**SCAUWG CHART MASTER Candy Robinson** has been analyzing the LA Charts for years, and as chairman of the SCAUWG Charting committee has been responsible for not only noting chart changes, but also for an amazing number of proposals submitted to the FAA that have resulted in better charting and increased LA AIRSPACE SAFETY.

**The following are her recent reports:**

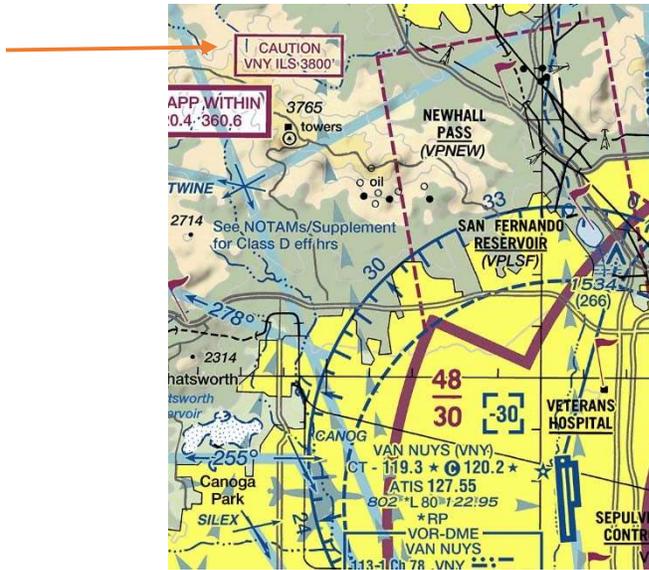
Long Beach Flying Club has received noise violations at LGB for VFR missed approaches outside the times permitted in the Airport Noise Compatibility Ordinance. It was pointed out to me that the listing for LGB in the Chart Supplement SW currently states:

Touch and go, stop and go, low apch only permitted 1500–0300Z‡ weekdays and 1600–2300Z‡ weekends and hol only on Rwy 08L–26R and Rwy 08R–26L.

It needs to be updated to:

Touch and go, stop and go, **practice** low apch, **VFR practice missed apch** only permitted 1500–0300Z‡ weekdays and 1600–2300Z‡ weekends and hol only on Rwy 08L–26R and Rwy 08R–26L.

### CHART SUPPLEMENT SW

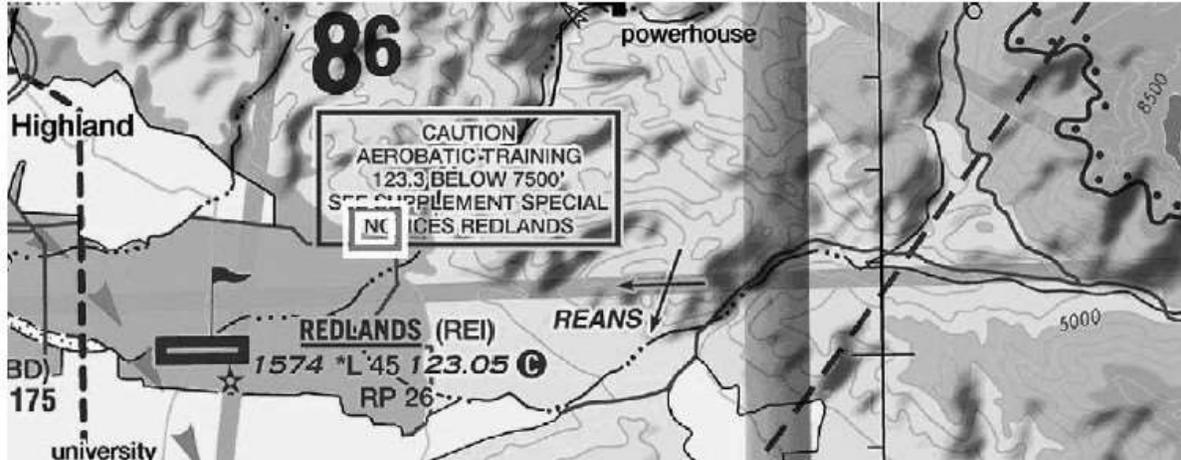
1. The traffic pattern altitude is still missing from the airport/facility directory listing for Long Beach Airport. I'm sure there is an explanation for not publishing the 1000 ft nonstandard traffic pattern at LGB.
2. In the section of the Chart Supplement, VOR RECEIVER CHECKPOINTS and VOR TEST FACILITIES, the VOT for Long Beach Airport has been corrected:

Long Beach (Daugherty Field)	113.9	G	Unusable all areas except runup Rwy 26L at Twy J, runup Rwy 26R.
------------------------------	-------	---	--

**AEROBATIC OPERATIONS NORTHEAST OF REDLANDS, CA**

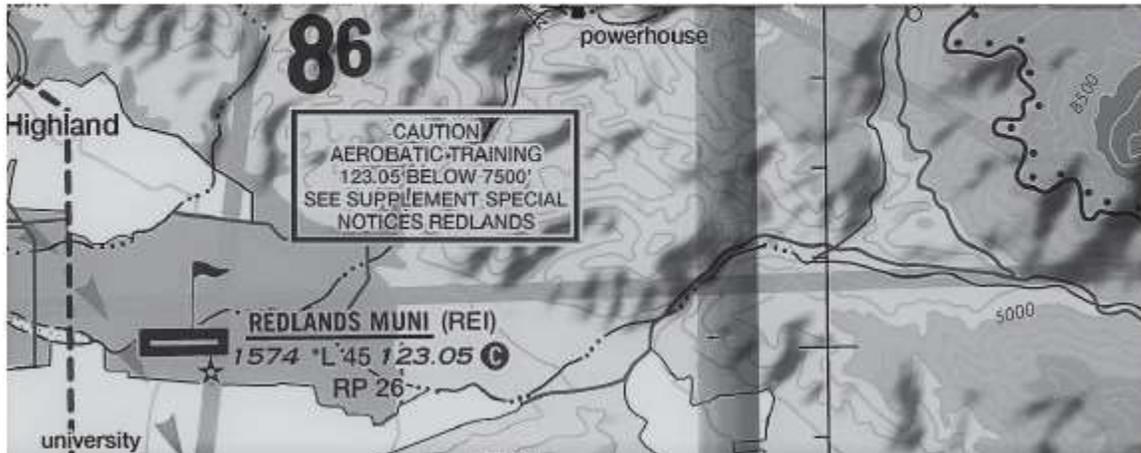
The current edition of the Chart Supplement omitted the aerobatic box that had been charted within the caution box. This is probably due to the recharting of Redlands (REI) to Redlands Muni (REI).
